PRATT & WHITNEY CANADA
SERVICE BULLETIN

P&WC S.B. No. 41122

TURBOSHAFT ENGINE
INCREASED NUMBER OF COMPRESSOR ROTOR BALANCING RIVETS AND WEIGHT

PT6C-67C, PT6C-67C1

Rivets and Weight - Installation of
Figure 1

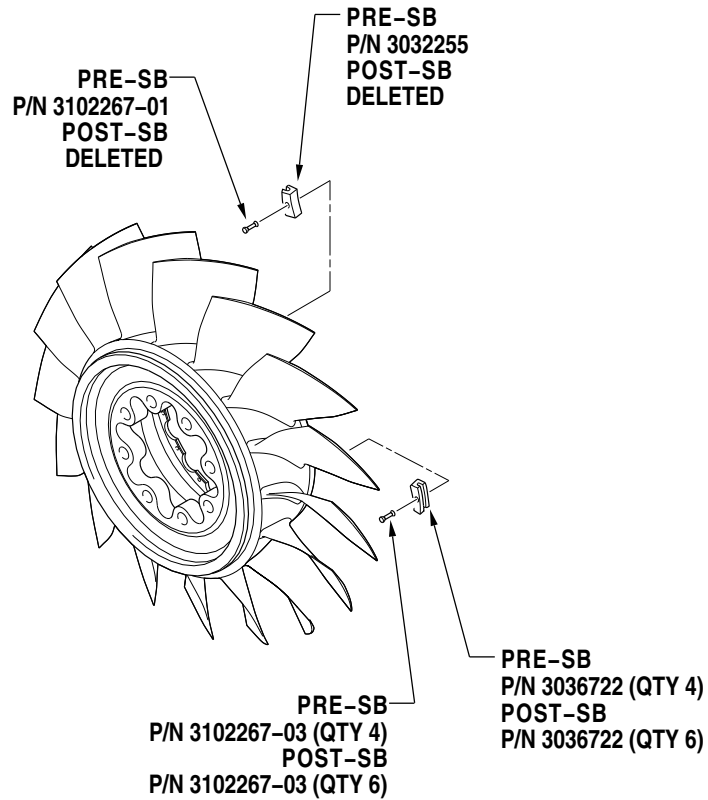
- remove the larger balancing counterweight and rivet combination,
- increase the quantity of the smaller balancing counterweight and rivet combination.

Replace the weights and rivets as required.

A. Remove the parts in the Old P/N list in Para. 2.C., Material Information, in accordance with the overhaul manual instructions as follows:

B. Install the parts in the New P/N list in Para. 2.C., Material Information, in accordance with the overhaul manual instructions as follows:

Fit 914
Figure 2

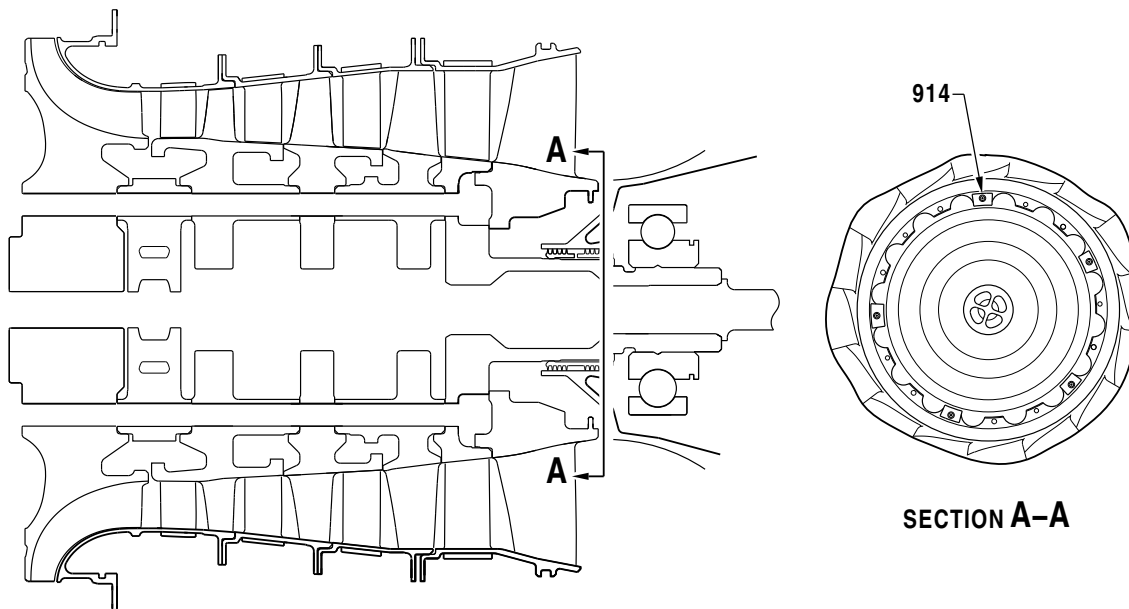
Refer to Table 1 and Figure 1 for Fits and Clearances.

REF. NO.	Name	Limits		Replace
		Min.	Max	
914	For balancing purpose: Use MAX 6 weights (P/N 3036722 CLASS 1 or 2) or MAX 6 rivets (P/N AN123152) or a combination of either P/N but not exceeding MAX 6 total do not use any other class.
